Product Change Notification (PCN)

Product Family

Series

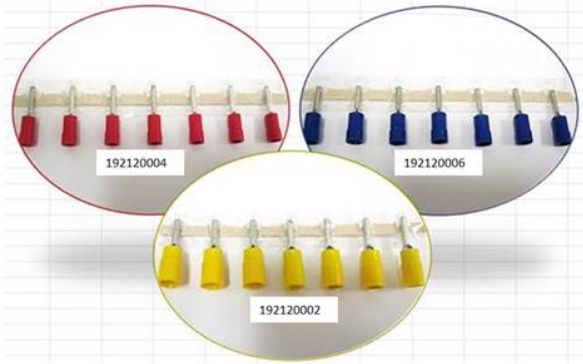
Reason for Change

Change Type Description

Before Change

After Change
